## Planning and Zoning AGENDA

Tuesday, May 19, 2020  
Ketchum City Hall  
480 East Avenue North, Ketchum, ID 83340

4. [ACTION - 3020 Warm Springs Rd. \(Waddell/Roush\) Duplex Design Review: 3020 Warm Springs Rd. \(Wills Condominium Subdivision No. 2\)](#) The commission will hold a virtual public hearing to consider and take action on a Design Review application submitted by architect Craig Lawrence, on behalf of property owners Doug and Stacey Waddell, for the development of a new duplex and associated site improvements within the General Residential Low Density (GR-L) Zoning District.

**STAFF REPORT**  
**KETCHUM PLANNING AND ZONING COMMISSION**  
**MEETING OF MAY 19, 2020**

**WADDELL/ROUSH DUPLEX**  
3020 WARM SPRINGS ROAD, KETCHUM, ID. 83340

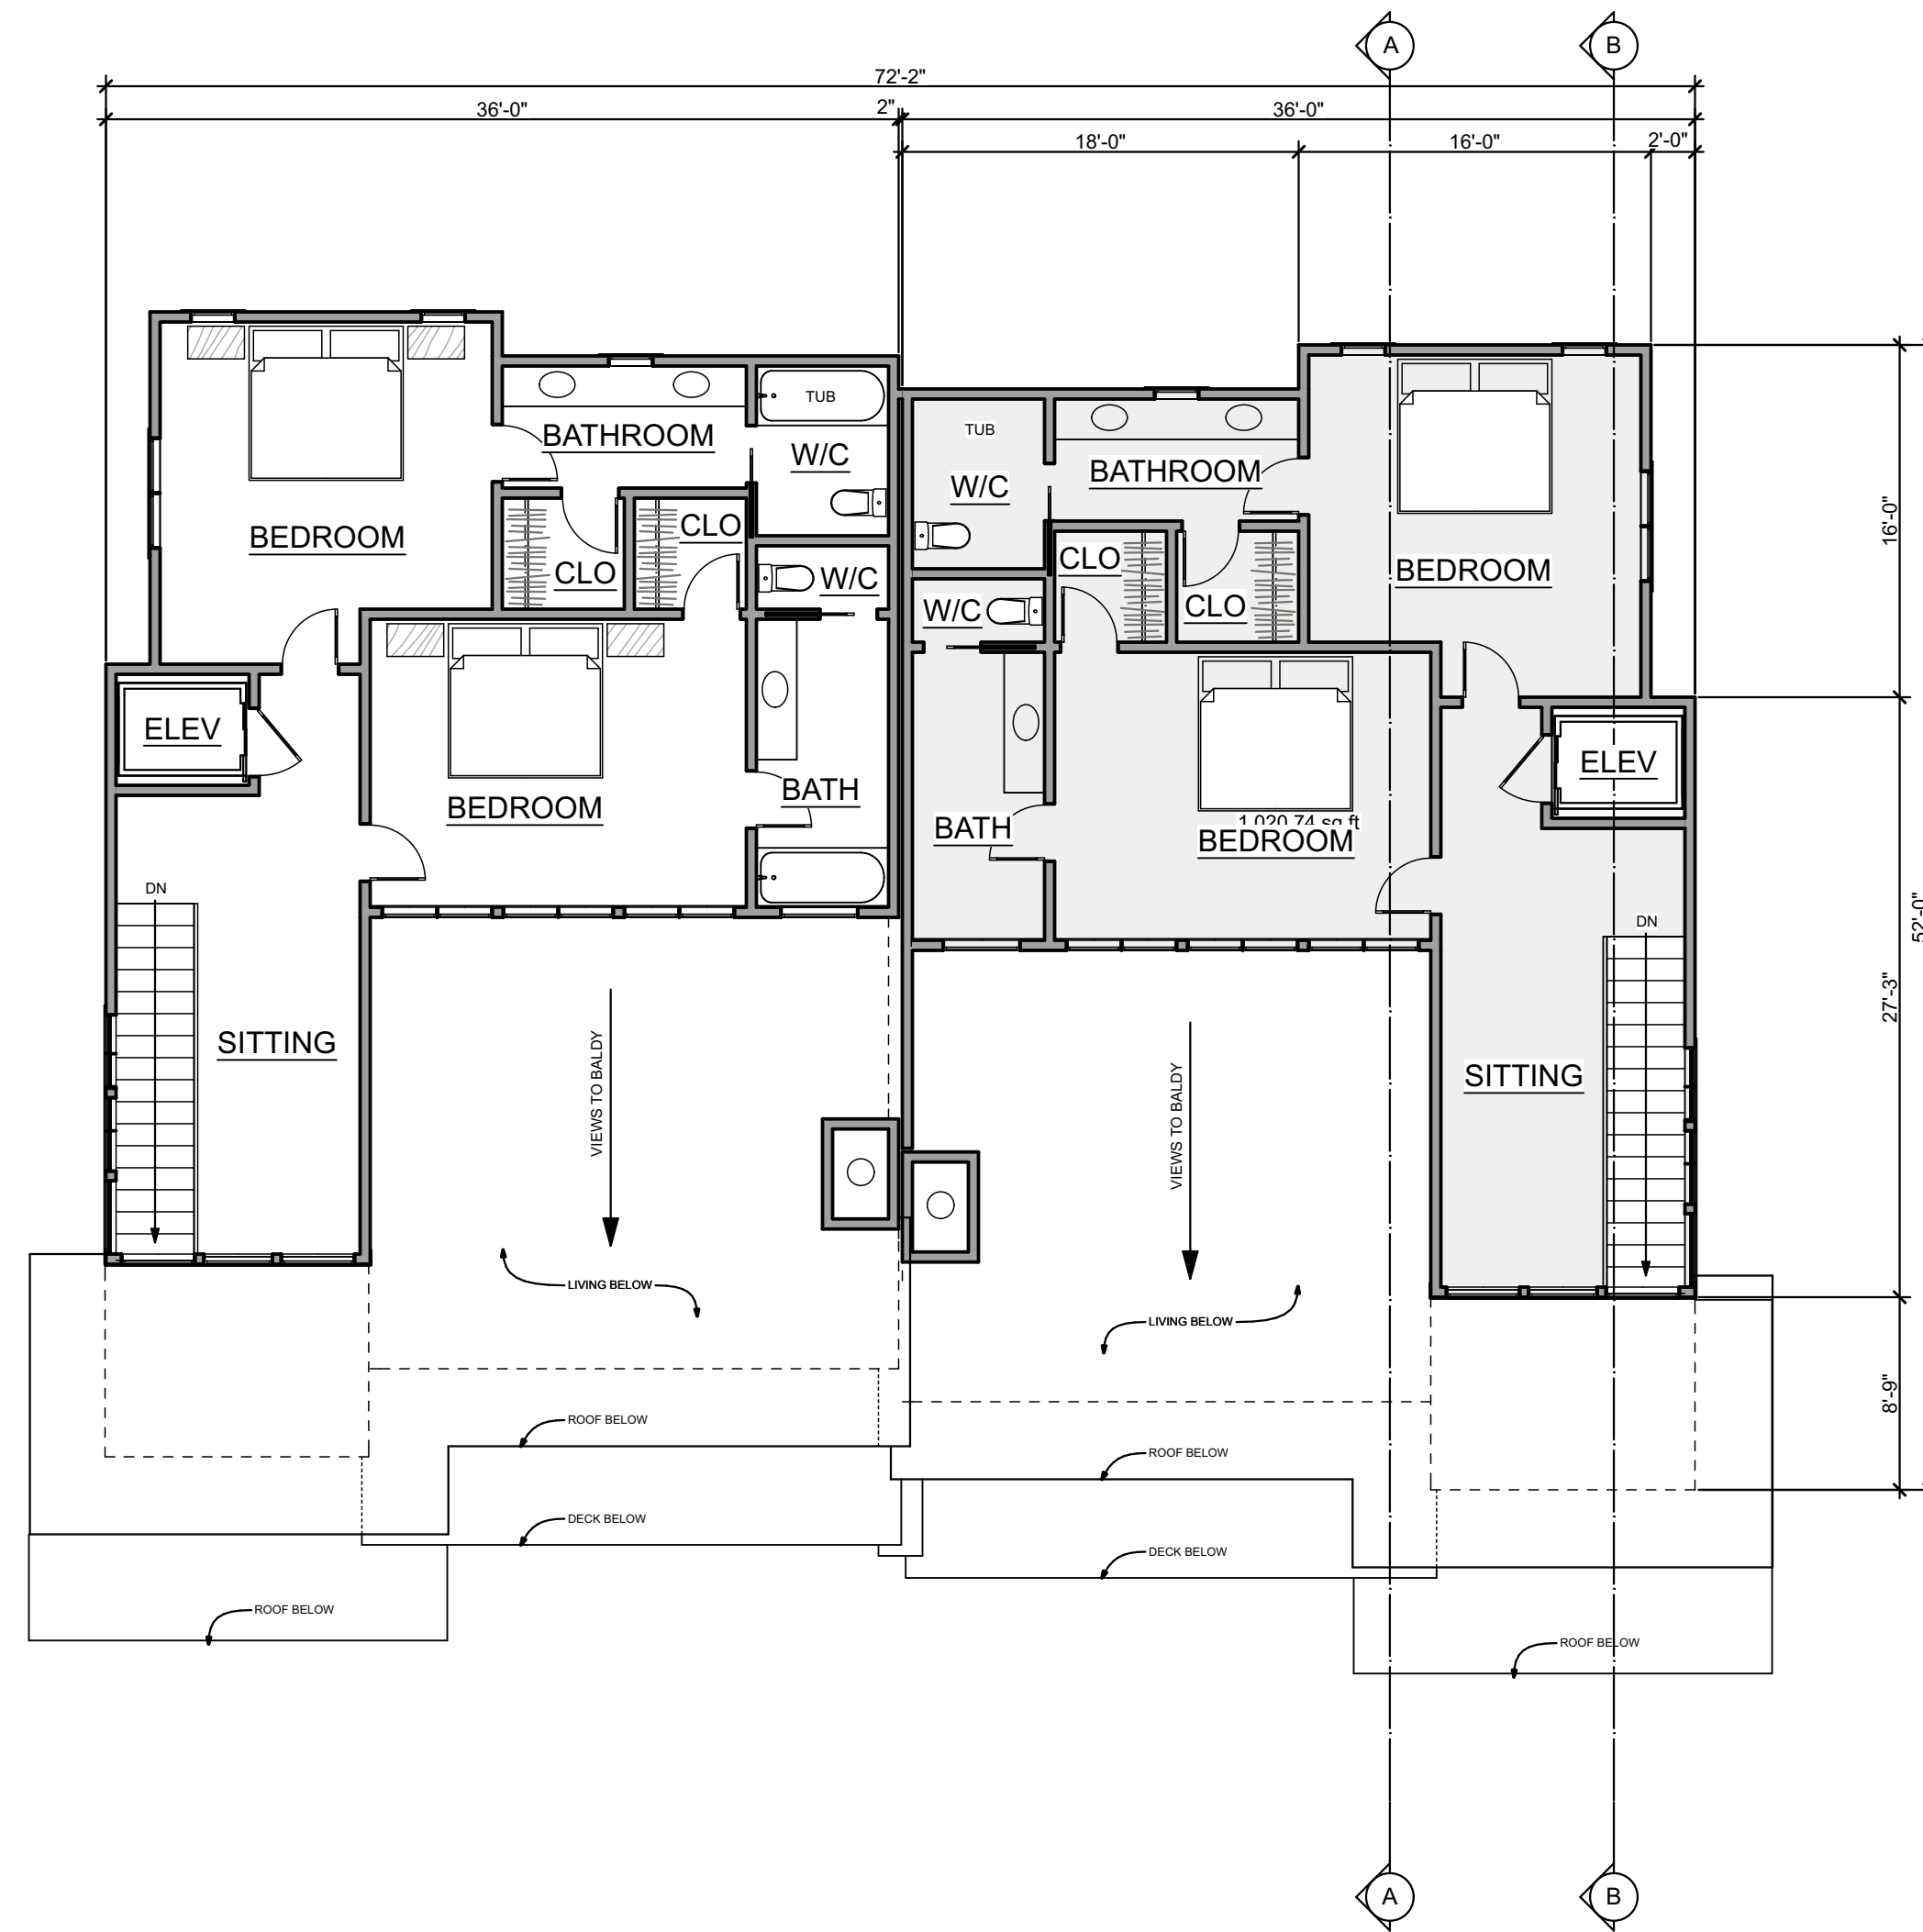
Building elevations are included on Sheets A-03 and A-04 of the project plans. The three floors are horizontally stacked on top of each other as one-story elements separated by a border of black fascia. The lack of sufficient vertical, two- or three-story elements incorporated into the façade design exacerbates the appearance of flatness.

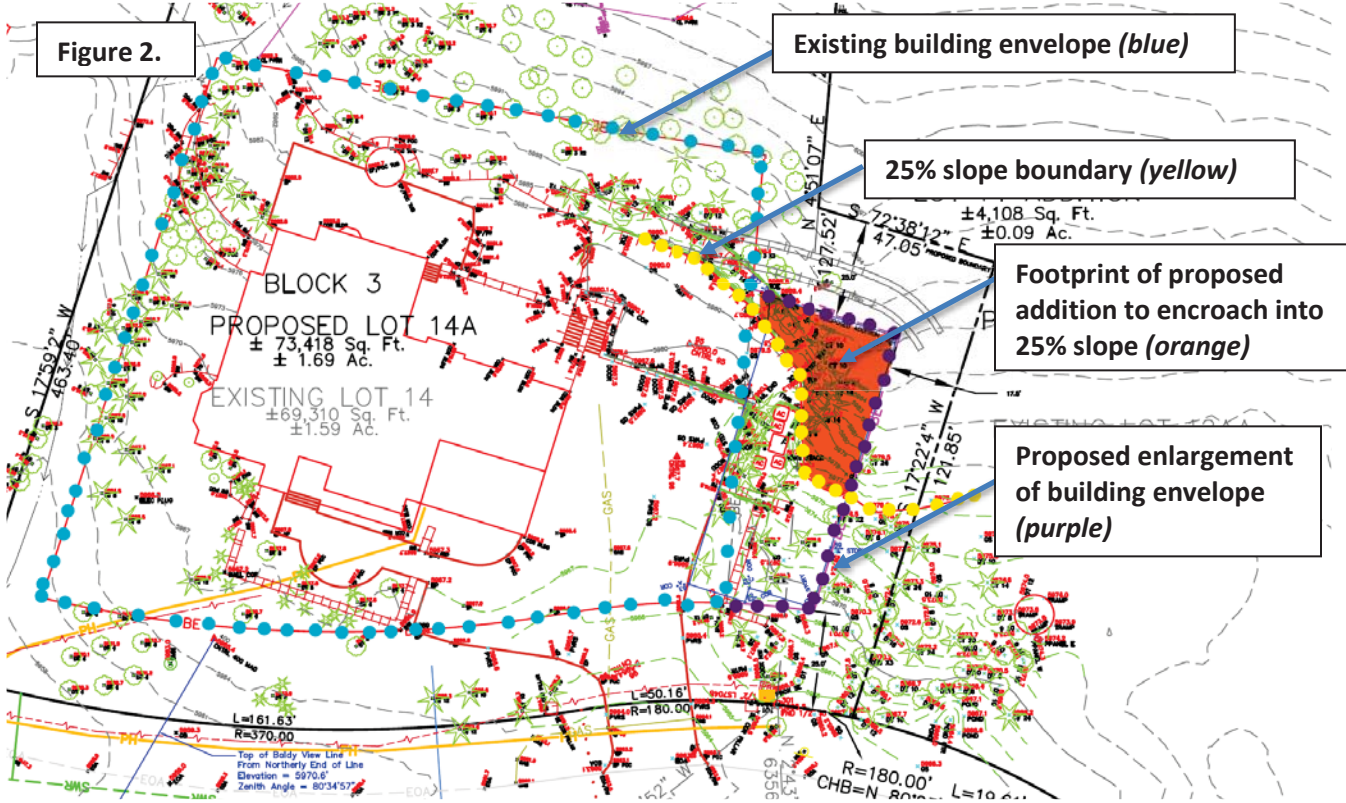
Figure 2., an excerpt of the Preliminary Plat prepared by Alpine Enterprises Inc. and annotated by staff, highlights the existing building envelope, the proposed enlargement of the building envelope, the 25% slope boundary, and the footprint of the proposed addition that would encroach into the 25% sloped area if approved.
